Item Name: Replacement Skidtube, High Gear with Standard Wearplates Fits LH or RH

Sequence ID/ Work Center ID	Operation Description	Set Up/ Run Hours	Tool ID	Tool #	Plan Code	Accept Qty	Reject Qty	Reject Number	Insp. Stamp
Draw Nbr	Revision Nbr	0.00	SP						
D2650	Rev F(DEO)								
100	Document Control	0.00							
100	DOCUMENT CONTROL								
DC	Memo	0.00							
Doc.Control -USB or Paperwork		Photocopy bluefile and create labels per PPP D206-642-441		CHG005

DRAWING NO. D2650	TITLE 206/407 SKIDTUBE ASSEMBLIES	REV. F	DART AEROSPACE LTD ENGINEERING ORDER		D.E.O. NO. D2650-F-1	SHEET NO. SHEET 1 OF 1	SCALE NTS
DRAWN 12.10.12	CHECKED A.P.	MFG. APPR.	APPROVED	DE APPR.	DATE 12.10.22	DATE 12.10.22	DATE 12.10.22

DETAIL B

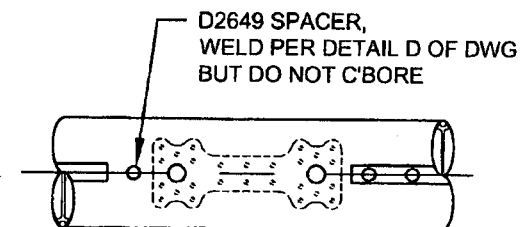
CHANGE C'BORED WELDED CROSSBOLT SPACERS TO SWAGED SPACERS

WAS:

17	18	19	23	D2649	CROSS BOLT SPACER
----	----	----	----	-------	-------------------

ADD DETAIL G BELOW, WHICH IS THE SAME SECTION VIEW AS DETAIL D OF DWG.
C'BORED HOLES ARE **NOW SWAGED** PER DETAIL G BELOW. FOR THE Ø0.375 HOLE THAT IS NOT C'BORED, WELD PER DETAIL D OF DWG (SEE AMENDED DETAIL B FOR REFERENCE).

AMENDMENT TO DETAIL B
NOT TO SCALE
